TITLE: PR-050, 052 AND 072 - 63FR56098 - CHANGES TESTS AND
EXPERIMENTS

CHANGES, TESTS, AND EXPERIMENTS

Changes, Tests, and Experiments; Correction

Figure 3-2. Example of Margin of Safety Using Containment Pressure Transient

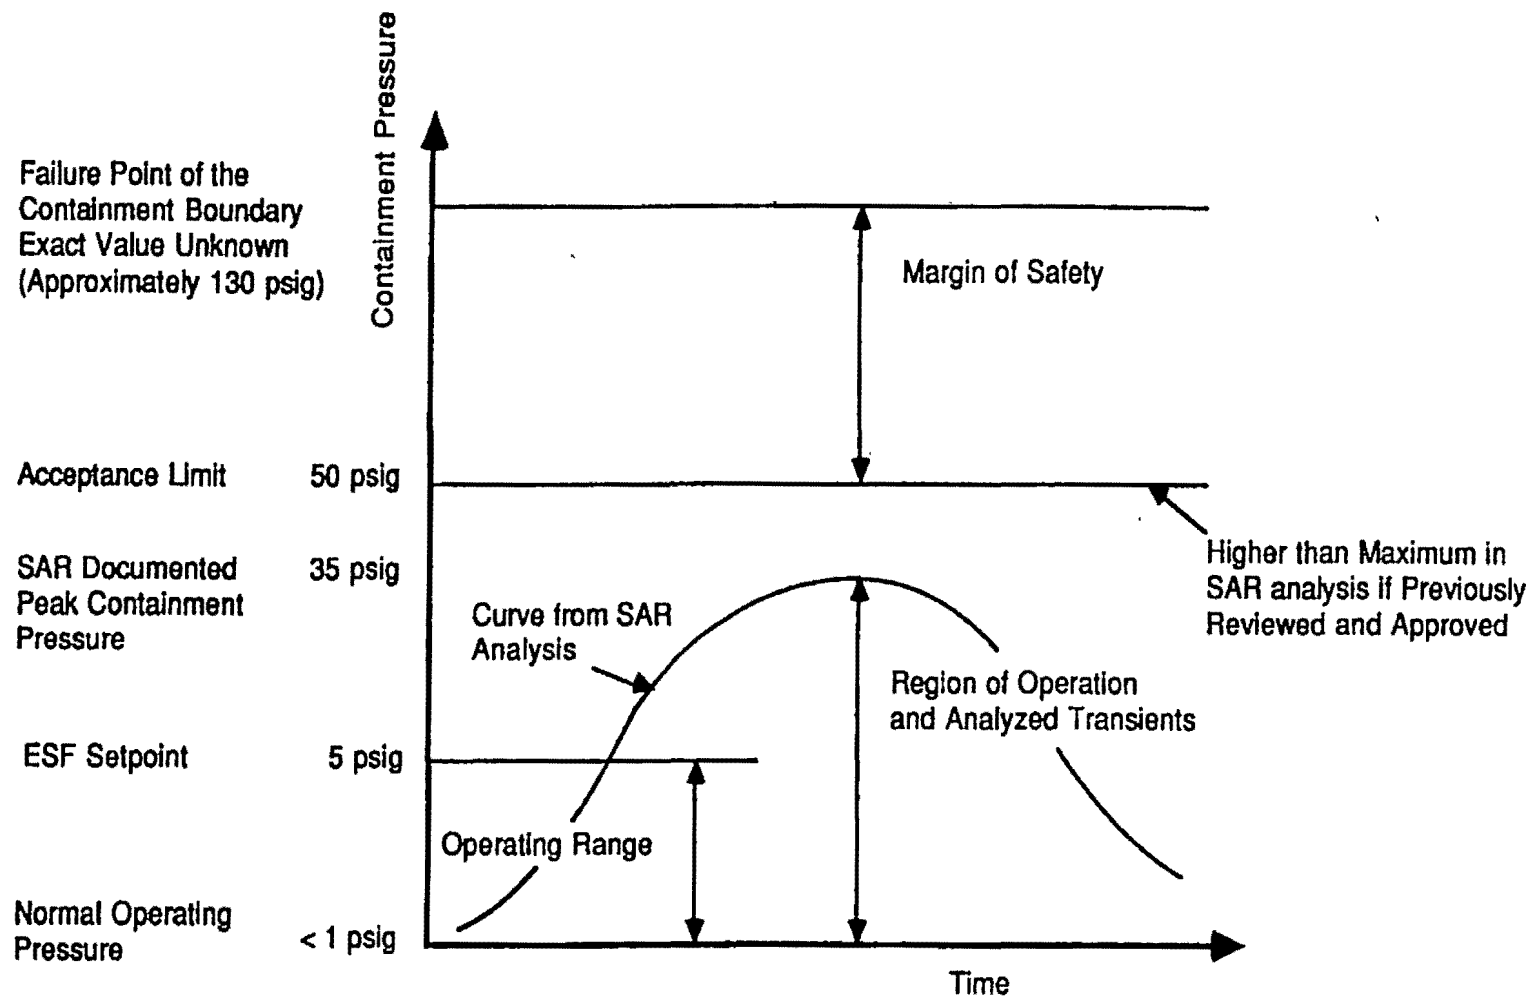
NEI 96-07, *Guidelines for 10 CFR 50.59 Safety Evaluations*, and NSAC-125 before it, provide guidance that is clearly consistent with the NRC view outlined above and specifically identified the three radiological barriers: fuel cladding, reactor coolant system (RCS) pressure boundary, and containment. Additionally, the industry guidance defines "margin of safety" as the region between the limit used as the basis for NRC approval of specific values in the FSAR ("acceptance limit") and the value that would cause failure of one of the three principle barriers (failure point). The following Figure 3-2 from the industry guideline illustrates the definition of "margin of safety."

The same 1968 Federal Register Notice cited above also makes clear that the scope of a "margin of safety" review is the information that forms the foundation of the technical specifications and is distinct from the technical specifications themselves.

Figure 1

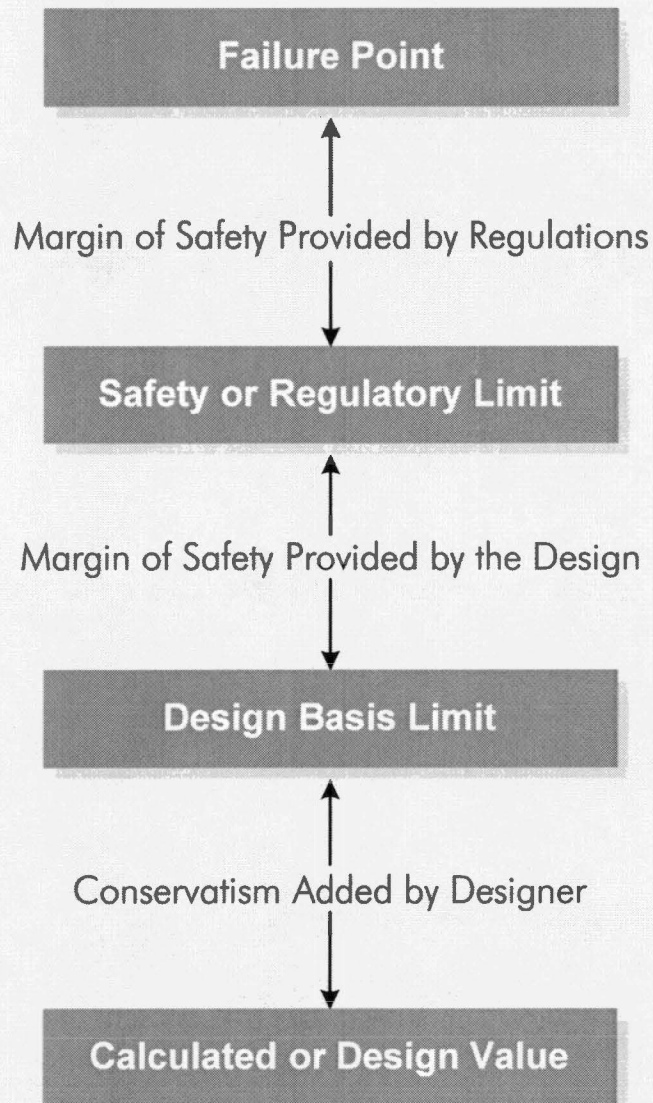
The NRC should define the margin of safety as the difference between the design basis limit and the safety or regulatory limits, and should allow licensees to make unlimited changes between the calculated values and the design basis limit. Specifically, margin of safety should be defined as shown on Figure 1.

As an example with respect to peak containment pressure during an accident, if the calculated pressure identified in the FSAR is 50 psig, but the licensee conservatively specified a containment design pressure of 55 psig, the margin of safety should be defined as the difference between the design pressure of 55 psig and the safety limit, and the difference between 50 and 55 psig should not be construed as part of the margin of safety. Any other result would penalize those licensees who conservatively established their design values.
